CHATTAHOOCHEE RIVERLANDS GREENWAY STUDY

SUB-AREA COMMITTEE MEETINGS SUMMARIES AND DIGITALLY SUBMITTED COMMENTS

SUBMITTED ON 11/5/2019

MAP L-107: ALIGNMENT ALTERNATIVES SUMMARIZED NOTES

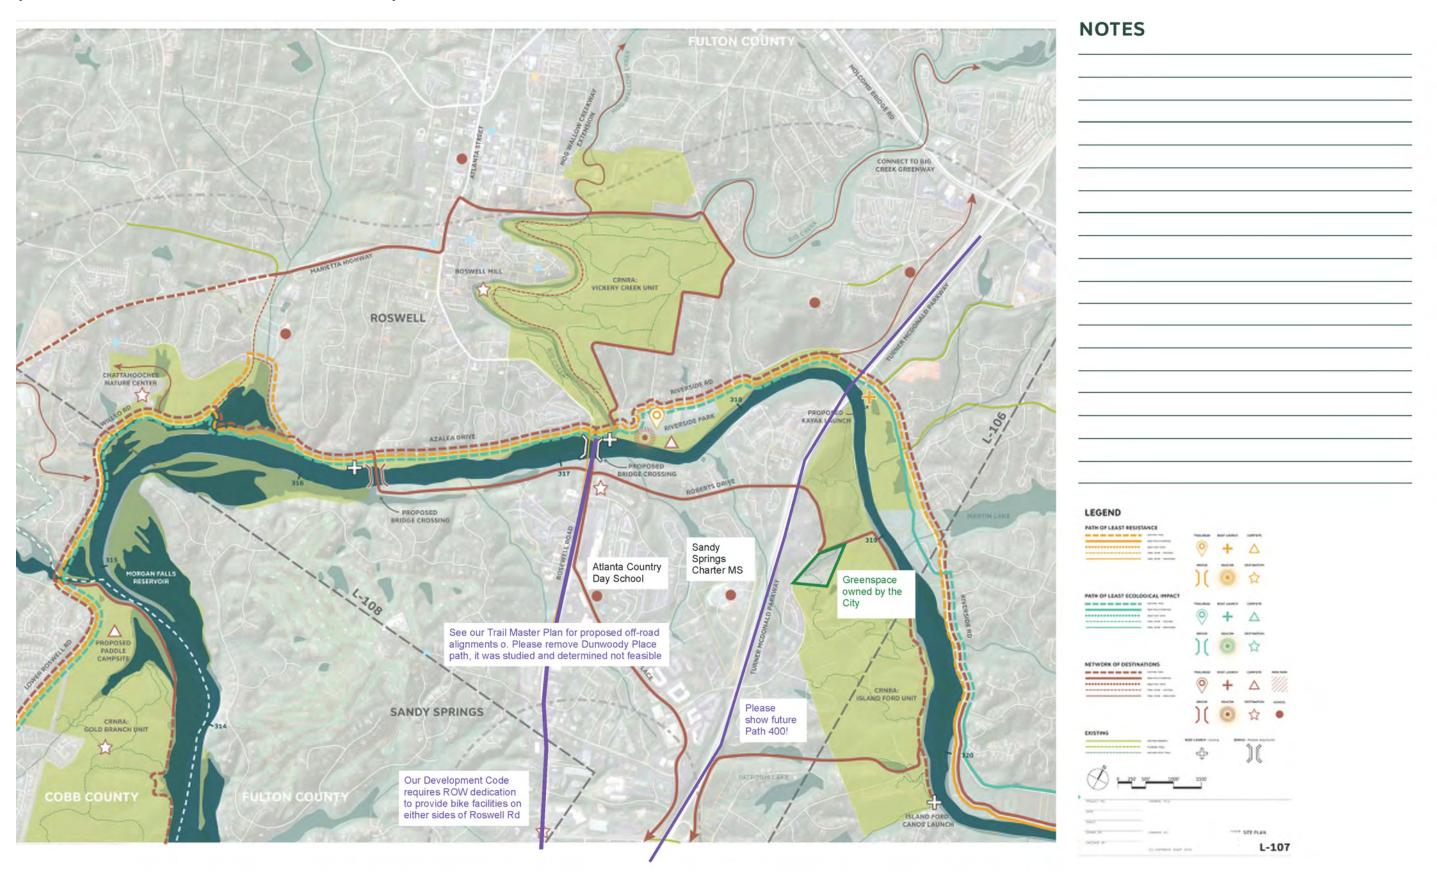
- NPS support for Path of Least Resistance
 - Remove all lines through Vickery Creek & Island Ford (NOD)
 - Greenway to (not through) Vickery Creek & Island Ford (NOD)
 - Two proposed bridge crossings is unnecessary
- No trails along Dunwoody Place (NOD)
- Need to Show Future Path 400 (Sandy Springs Masterplan)
- Sandy Springs Development code requires ROW dedication for bike facilities along Roswell Road – makes this a potential trib trail

MAP L-108: ALIGNMENT ALTERNATIVES

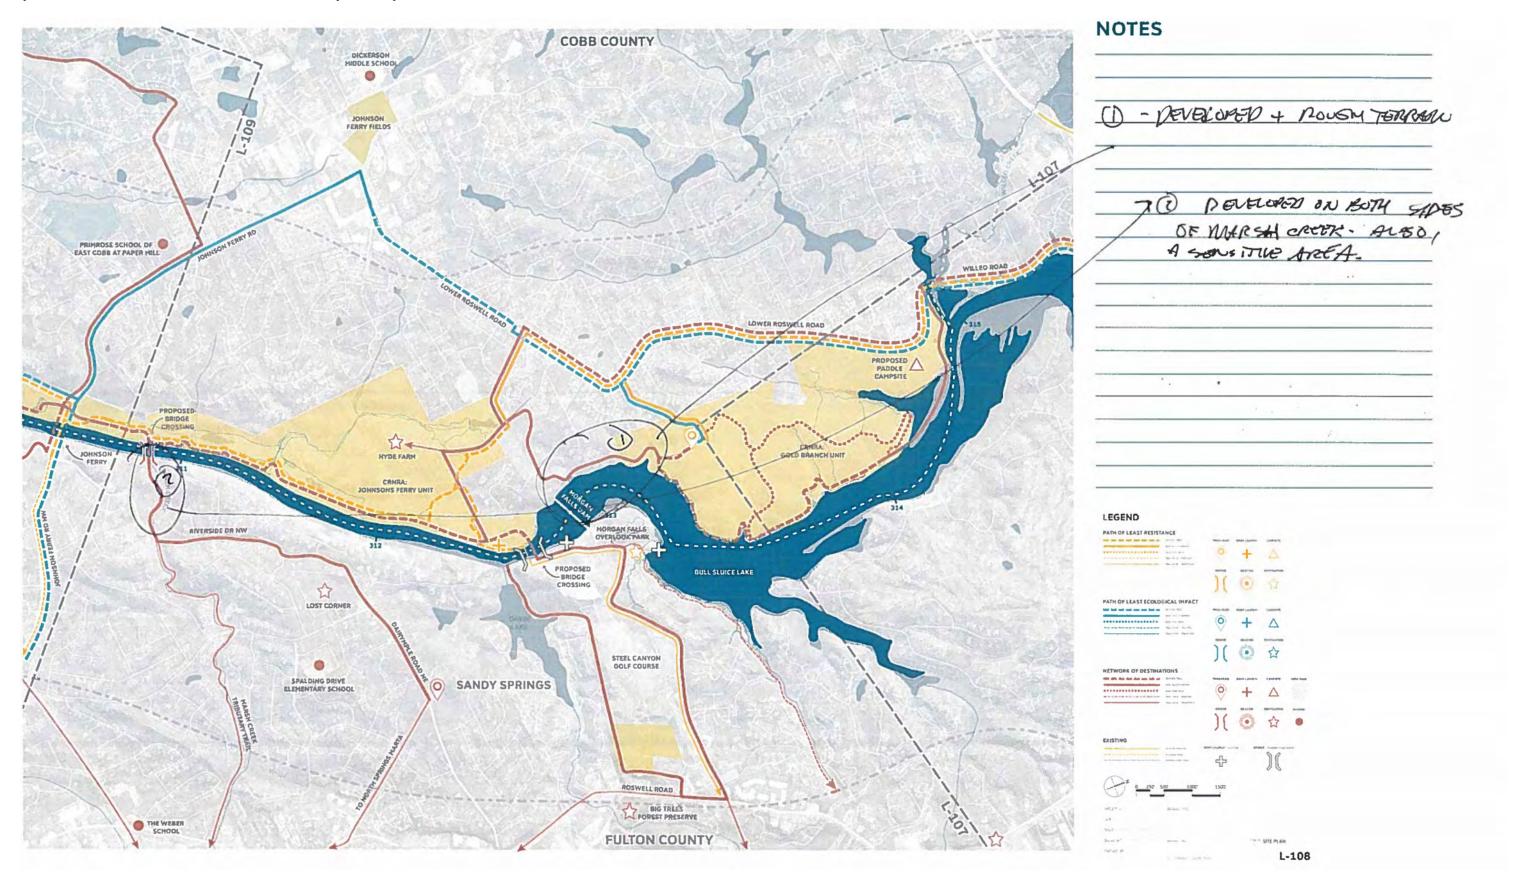
- NPS recommends Path of Least Resistance (conceptually), and Eco alternative in addition, which could more readily accommodate road bikes.
 - Rather than a boat launch on Cobb side (not feasible), they recommend a canoe share station on Sandy Springs side.
 - No trails through Gold Branch (NOD) follow Least Resistance or Eco alternatives
 - No multipurpose trail through Hyde Farm (NOD)
- Need to follow NPS lead regarding:
 - How to proceed with Hyde Farm and their desire not to lead people directly to the property itself
 - The proposed crossing
- Proposed NOD Crossing along Marsh Creek – in a sensitive area / unlikely
- On East side, NOD Trail in conflict with Sandy Springs Masterplan which shows trail along south side of Orkin Lake
- Sandy Springs recommends connecting both segments of Riverside Drive

MAP L-109: ALIGNMENT ALTERNATIVES SUMMARIZED NOTES

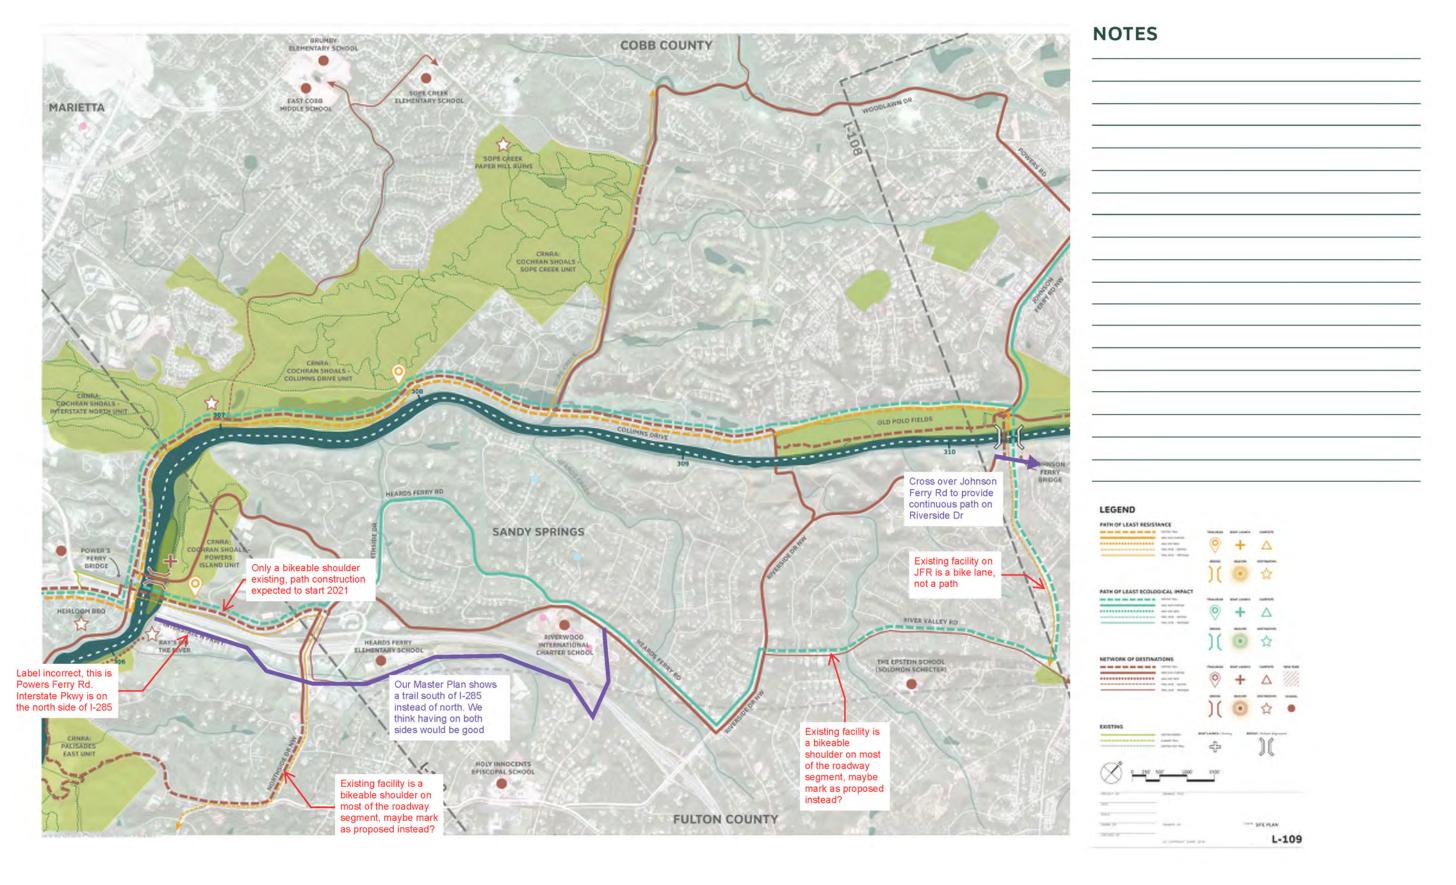
- Desire to connect Palisades and Cochran Shoals on Cobb side
- Columns Drive is already well used by both bikes and peds could use some improvements
 - Could come off Columns drive and go around pond to the west
- No Trail Along Sope Creek
- No Trails through Johnson Ferry South (Old Polo Fields)
- No NOD trail through Cochran Shoals
- Potential for a trailhead at Johnson Ferry Bridge
- Sandy Springs Master plan shows a trail south of I-285 instead of North, but they think having trails on both sides would be good (see Sandy Springs notes)
 - Suggested cross-over Johnson Ferry Road to provide continuous path on Riverside Drive

MAP L-110: ALIGNMENT ALTERNATIVES SUMMARIZED NOTES

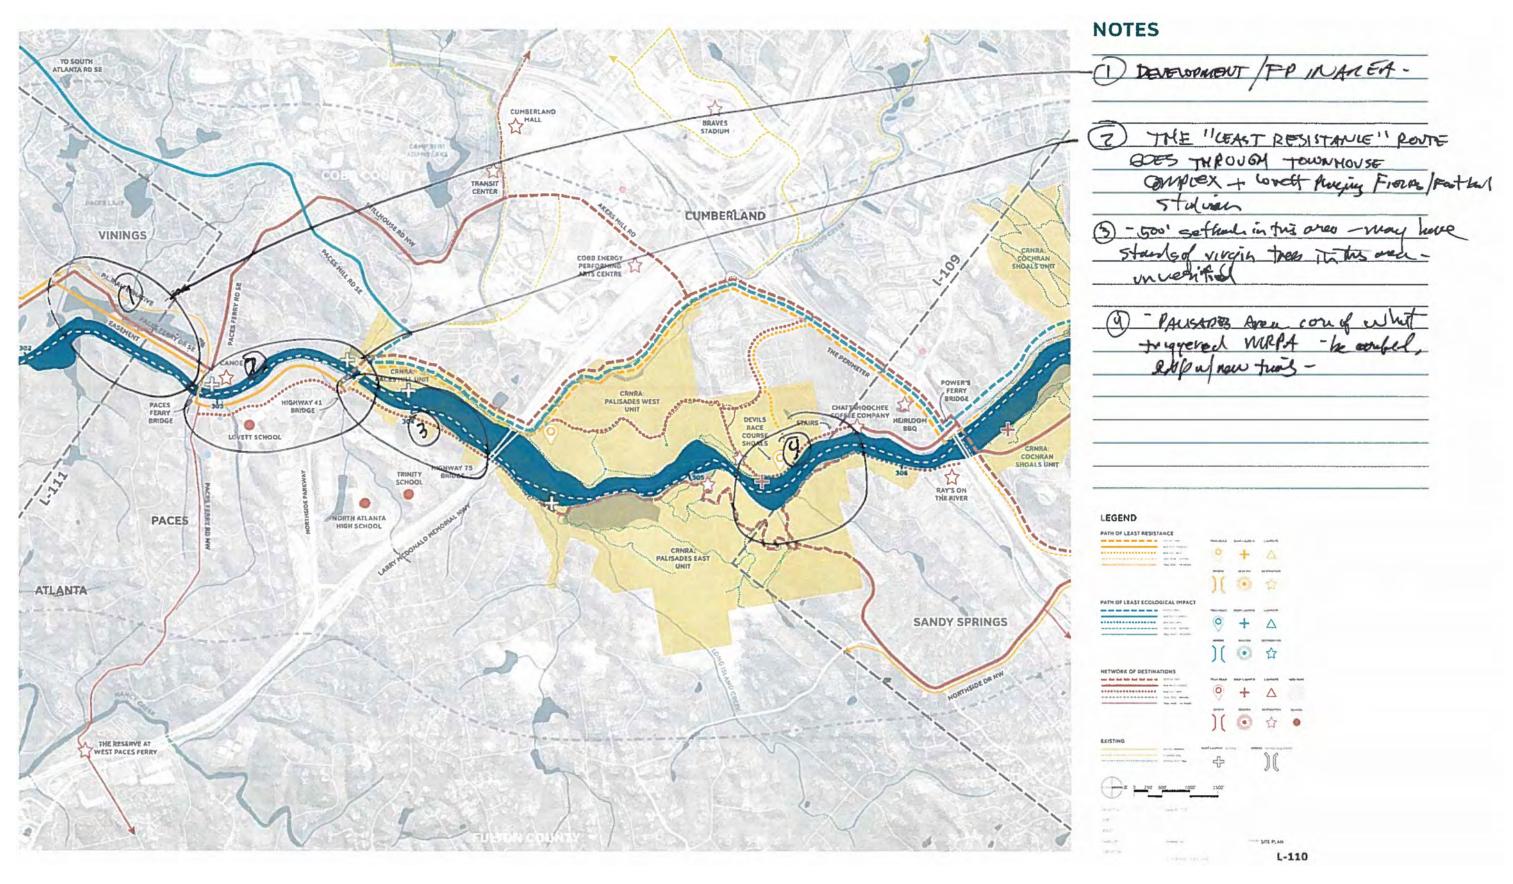
- No easy answers on East side of river
 - CPC has recommended avoiding development in the East Palisades due to steep and sensitive slopes.
 - Even outside of the Park unit, surrounding areas on the East side are very sensitive, not only in terms of ecology but also in terms of proximity to Lovett School playing field and townhouse complex
- National Park Service has indicated the Eco trail is their preferred option, with a trailhead at Pace's Mill (both trail heads show should be moved)
 - No proposed new trails through East & West Palisades.
- Extending connectivity along West bank would be amazing, pulling everything together from Columns Drive to Highway 41.
- Bridge from Rottenwood Creek to Long Island then Long Island to Whitewater trail is favorable
 - Essentially hinges on a pedestrian bridge under I-75 bridge.

MAP L-110: ALIGNMENT ALTERNATIVES

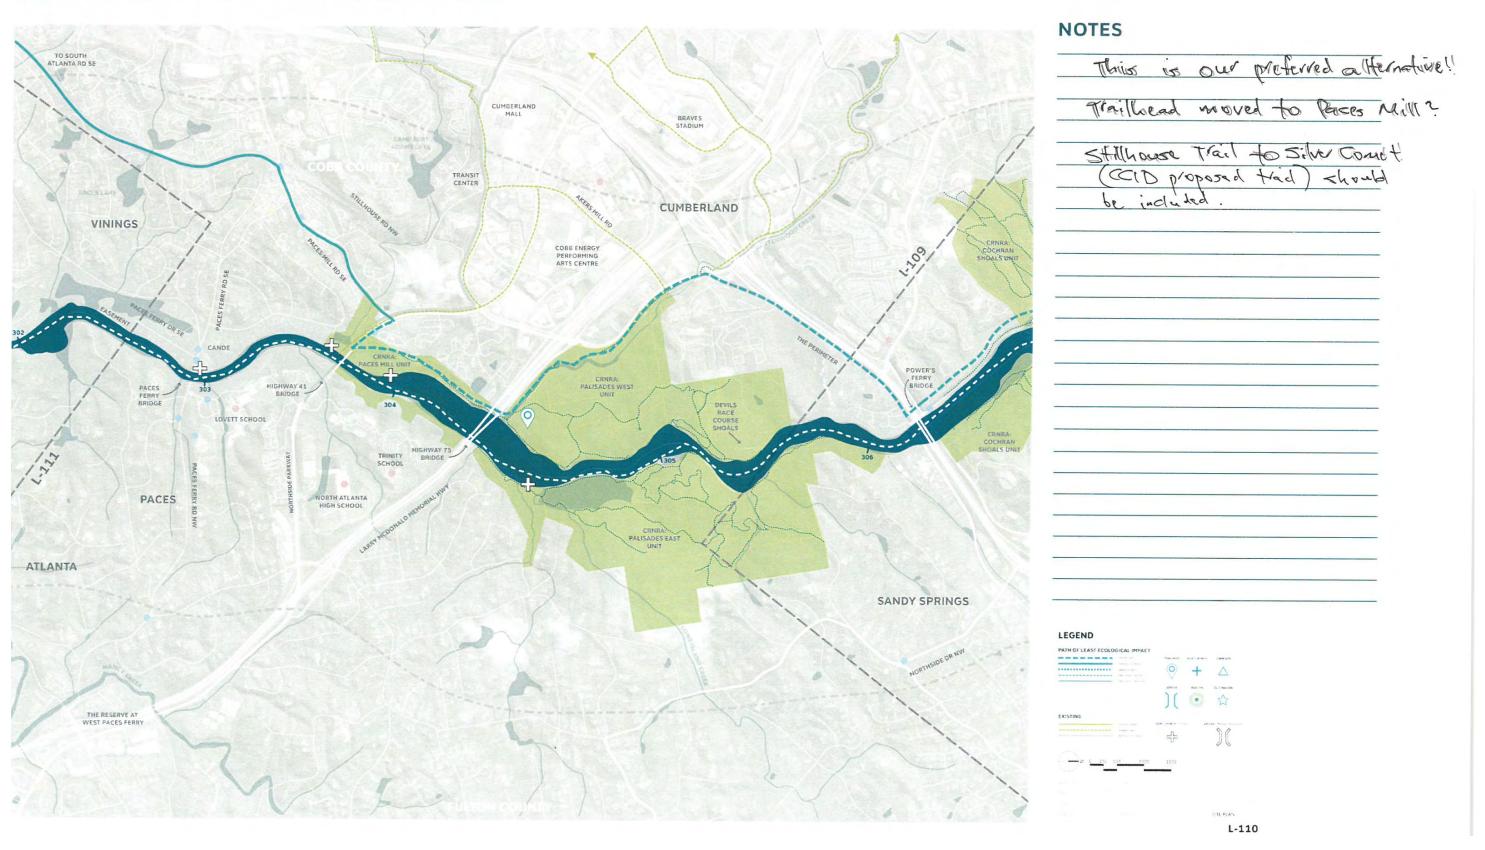
General: The section of river between 285+75 in one of the most scenic in Metro Atl. Take advantage. DExtending existing trail to provide continuity on the West bounk would be amazing !! It would pull overything together from Solumns Dr. to Hwy 41.

The Bob Gallahan Trail Glong Rottenwood Creek has now been extended to Interstate N. Pkwy (multi-use) (July 19) Therestate M. Fray (multi-use) (July 19)

(3) Long Toland is not shown

(9) A bridge from Ruttenwood Greek to Long

Island, then from the N. tip of Long

Island to the Whitewater Trail would

be fantastic: connects the two sides

to form a loop trail... (Rare)

(5) Explore opposite brunk? No easy answers

MAP L-112: ALIGNMENT ALTERNATIVES SUMMARIZED NOTES

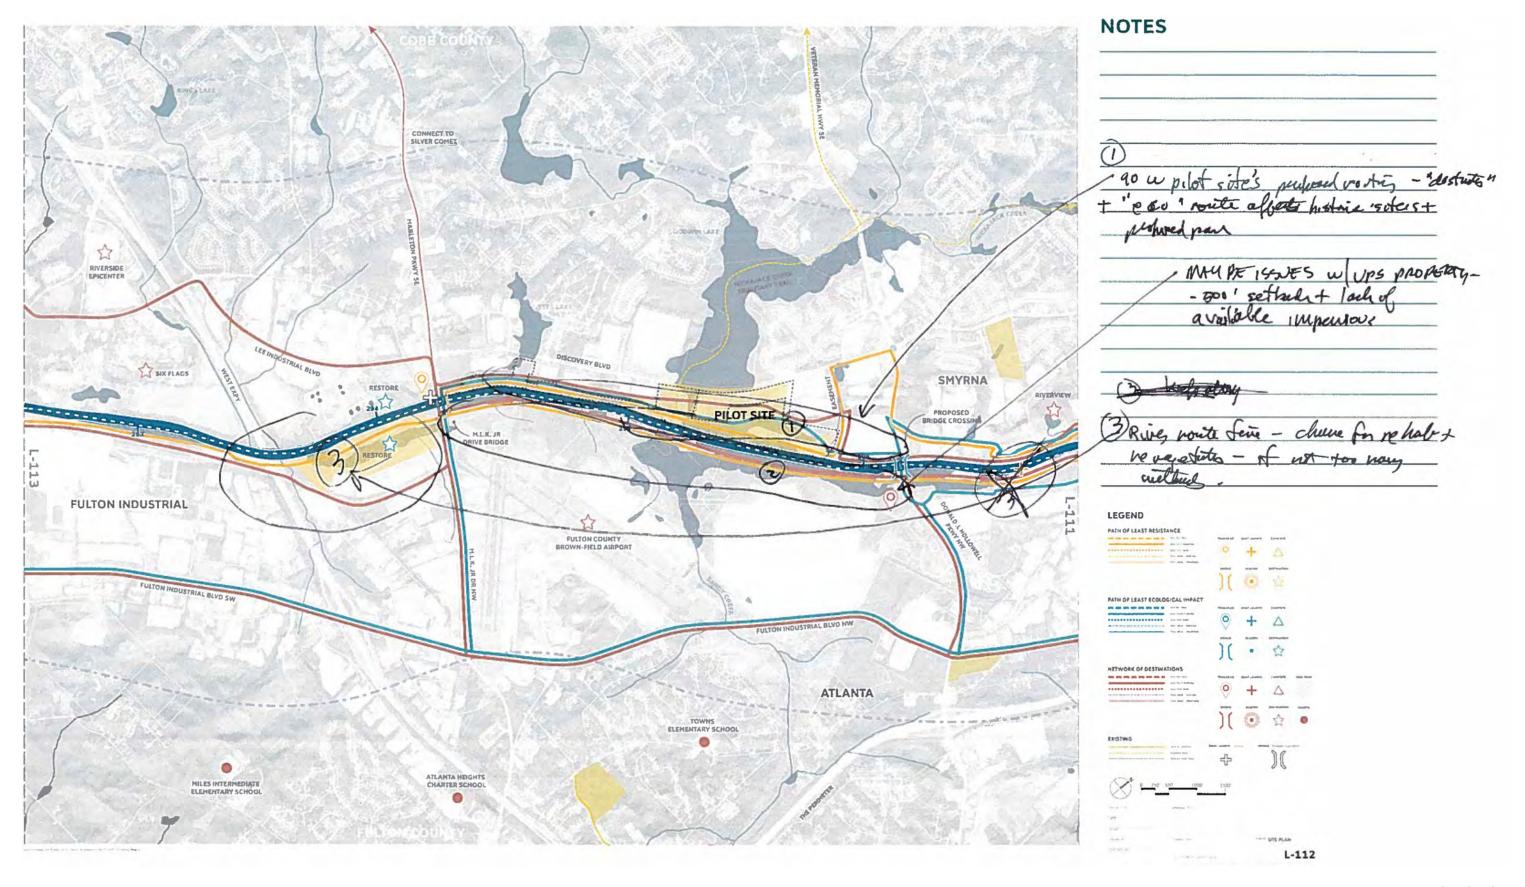
- Restoration opportunities at the mouth of creek that drains from Jett's lake and at the mouth of Nickajack Creek.
 - Also at proposed restoration site at the corner of MLK Jr Drive and the River – indicated preference for riverfront route.
- Jim Santos Preference for Path of Least Resistance through pilot site, expressed concerns about routes through Fulton County Airport
- Proposed park adjacent to Mableton Parkway SE – now included as one of the demonstration sites.
- Equity opportunities and concerns East of Fulton Industrial See SAC Notes
- Proposed Eco bridge is a great opportunity, could also "go under"

MAP L-114: ALIGNMENT ALTERNATIVES SUMMARIZED NOTES

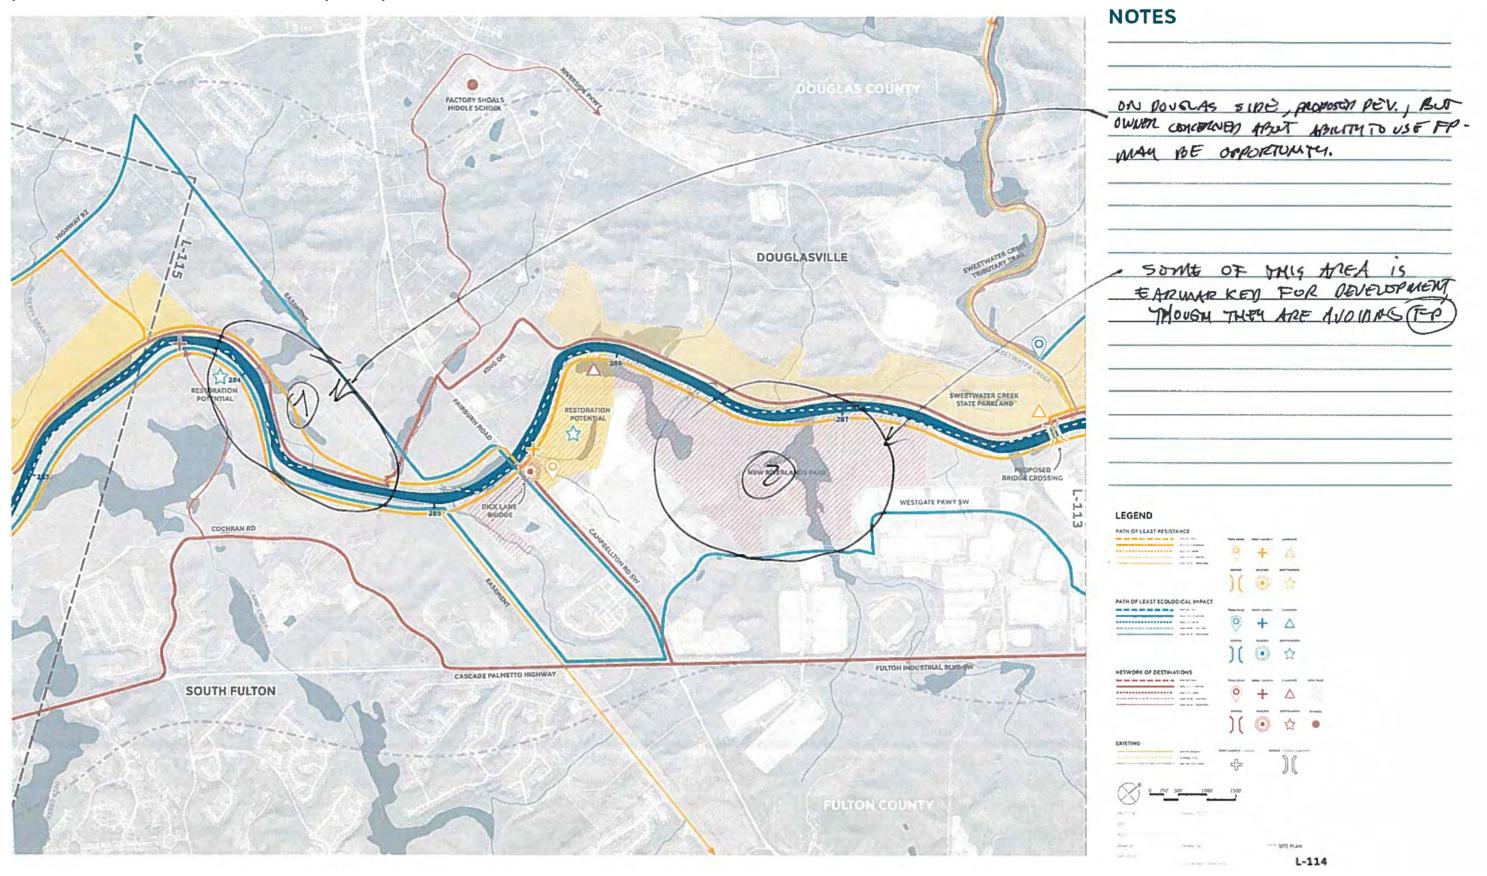
- Potential to expand new Riverlands Park
 - to proposed Least Resistance bridge crossing to the North
 - to Camp Creek to the South (See CWG markup)
- Sweetwater Creek State Park would prefer if trail did not go through park on the West side. Instead connecting to existing bike and pedestrian lanes on Riverside Parkway.
- Given the choice between Campbellton Road SW and the Easement, easement might be preferable
- If bridge on Campbellton Road SW is tall enough, it might be better to run the trail underneath existing bridge
- Proposed development on Douglas County side
 might be some opportunity in the floodplain
- Bus stops and new sidewalks being implemented on Fulton Industrial Blvd.
- Least Resistance Bridge Proposal bridge is being rehabbed in the Spring
